**CALIFORNIA
ADOPTED THE FOLLOWING:**

FINAL EXPRESS TERMS
FOR STATE AGENCY APPROVED CHANGES
TO
THE 2015 INTERNATIONAL BUILDING CODE (IBC) AND INTERNATIONAL EXISTING
BUILDING CODE (IEBC)
FOR
THE 2016 CALIFORNIA BUILDING CODE (CBC) AND CALIFORNIA EXISTING BUILDING
CODE CALIFORNIA CODE OF REGULATIONS (CCR), TITLE 24, PART 2 & 10

BUILDING & EXISTING BUILDING

FIGURE 11B-703.7.2.6.4
EDGES AND VERTICES ON GEOMETRIC SYMBOLS

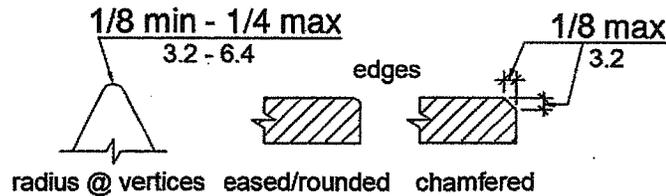
11B-703.7.2.6.4 Edges and vertices on geometric symbols. Edges shall be eased or rounded at 1/16 inch (1.59 mm) minimum, or chamfered at 1/8 inch (3.2 mm) maximum. Vertices shall be radiused between 1/8 inch (3.2 mm) minimum and 1/4 inch (6.4 mm) maximum.

Figure 11B-407.2.3.1
Floor Designations on Jambs of Elevator Hoistway Entrance Entrances

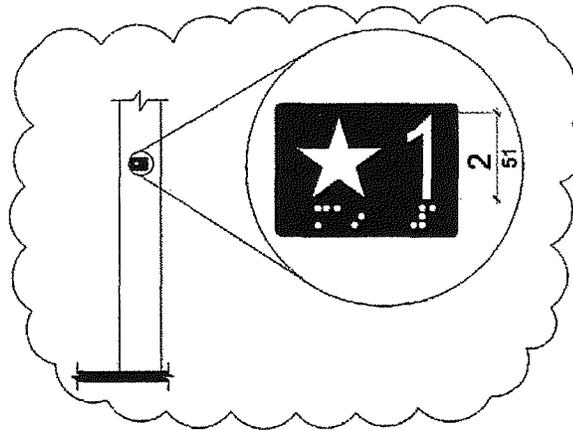
11B-407.2.3.1 Floor designation. ...

Figure 11B-411.2.3
Floor Designation and Car Designation Signs on Jambs
of Destination-Oriented Elevator Hoistway Signs Entrances

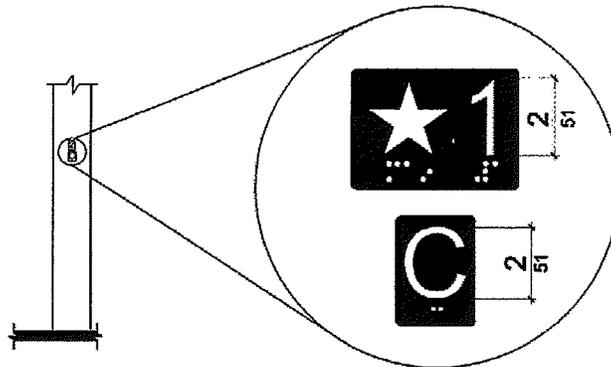
11B-411.2.3 Signs on jambs of elevator hoistway entrances. *Signs on jambs of elevator hoistway entrances shall comply with Section 11B-411.2.3.*

**FIGURE 11B-812.9
SURFACE MARKING**

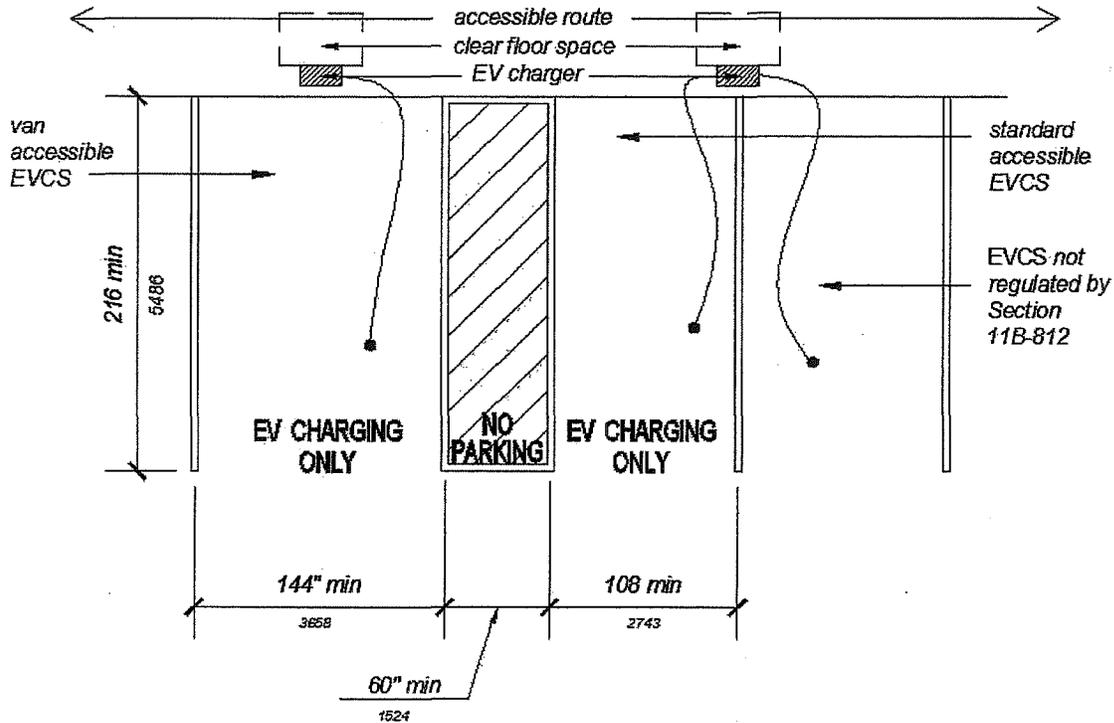
11B-812.9 Surface marking. EVCS vehicle spaces shall provide surface marking stating "EV CHARGING ONLY" in letters 12 inches (305 mm) high minimum. The centerline of the text shall be a maximum of 6 inches (152 mm) from the centerline of the vehicle space and its lower corner at, or lower side aligned with, the end of the parking space length.

11B-404.2.9 Door and gate opening force. ...

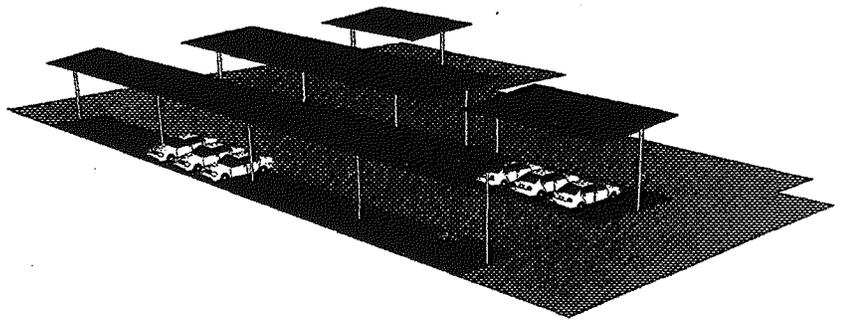
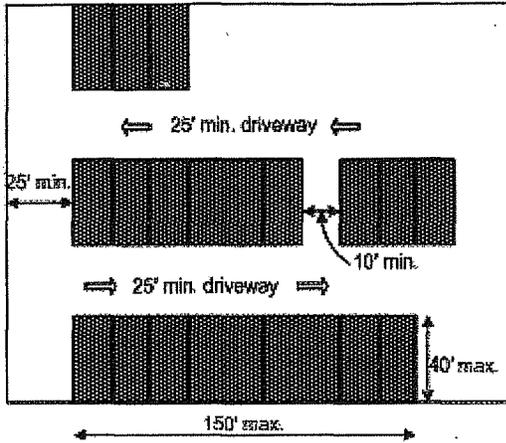
3. Other than structural requirements, solar photovoltaic panels supported by a structure over parking stalls shall not constitute additional story or additional floor area and may exceed the height limit as specified in exception 2 (above) when the following conditions are met (see Figure 5-1):

1. The area within the perimeter of the photovoltaic array has maximum rectangular dimension of 40 feet by 150 feet.
2. The distance between solar photovoltaic array structures is a minimum of 10 feet clear.
3. The driveway aisle separating solar photovoltaic array structures has a minimum width of 25 feet clear.
4. Solar photovoltaic array structure is used only for parking purposes with no storage.
5. Completely open on all sides (other than necessary structural supports) with no interior partitions.
